ST-HL-AE-4261

South Texas Project  
Units 1 and 2  
Docket Nos. STN 50-498, STN 50-499  
Request for Additional Information Regarding  
Review of the Proposed Changes to the South Texas Project  
Technical Specifications (TAC NOS. M76048 and M76049)

**Attachment 1**  
**Responses to the NRC Regarding the Risk-Based**  
**Evaluation of STPEGS Technical Specifications**

# AUXILIARY FEEDWATER SYSTEM UNAVAILABILITY FROM 11-89 TO 8-92

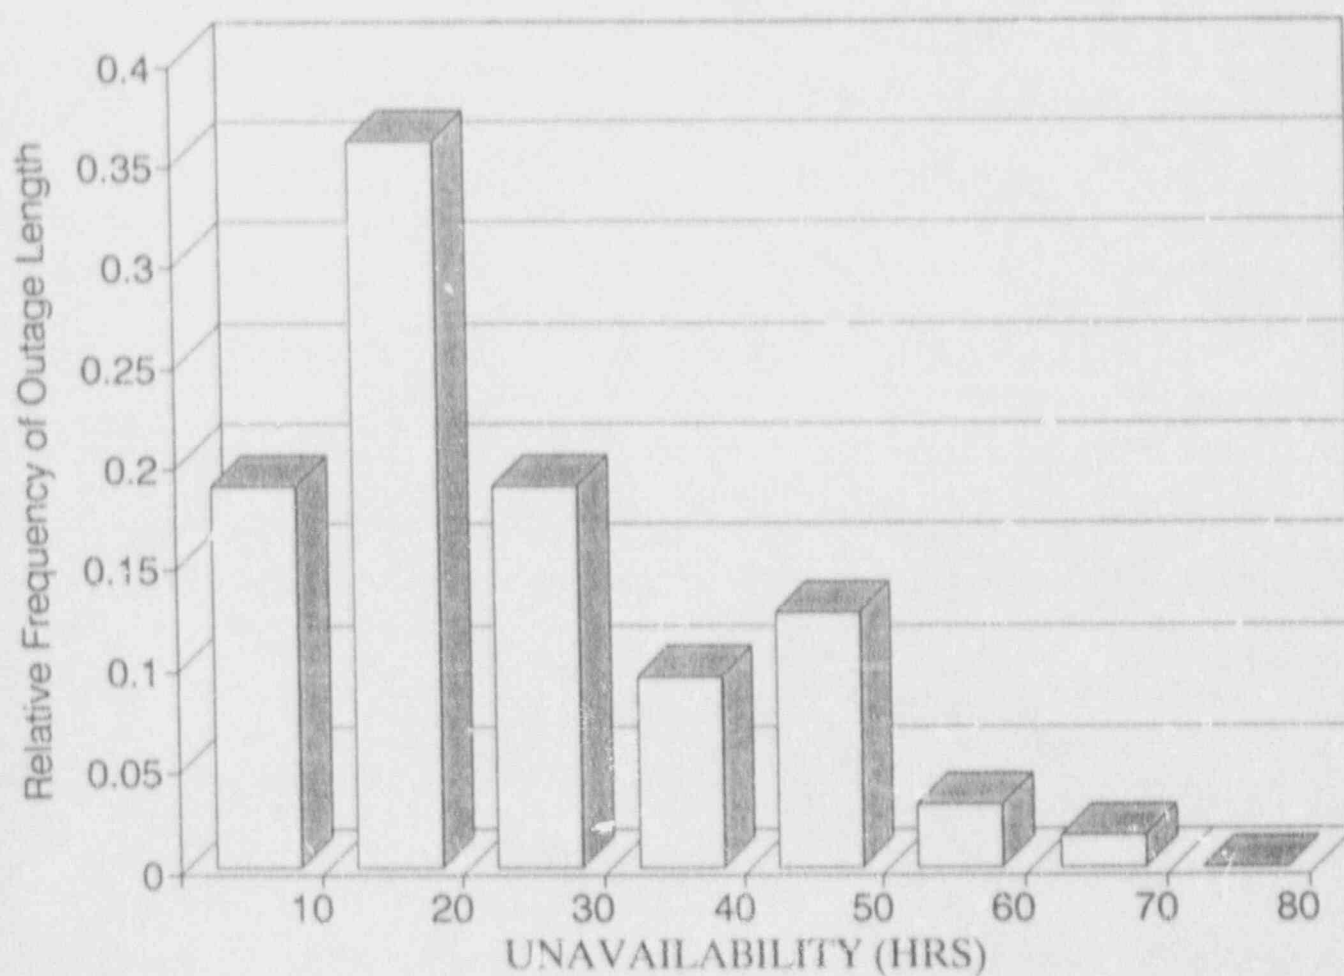
5. Provide STP-specific data on the repair times (including major findings on causes of component failure) used for the safety trains for which AOT changes are requested. This data should cover a minimum of a 144 week period and should include the repair time (portion of the AOT) for which the train was unavailable (i.e., for which the LCO condition was entered).

The data is plotted as the relative unavailability of each system train verses the OOS time in hours. Figures 1 through 11 display the data in a graphical form. Table 1 presents the lognormal mean, in hours, of train-wise outages, along with the 5<sup>th</sup>, 50<sup>th</sup> and 95<sup>th</sup> percentile of the lognormal distribution.
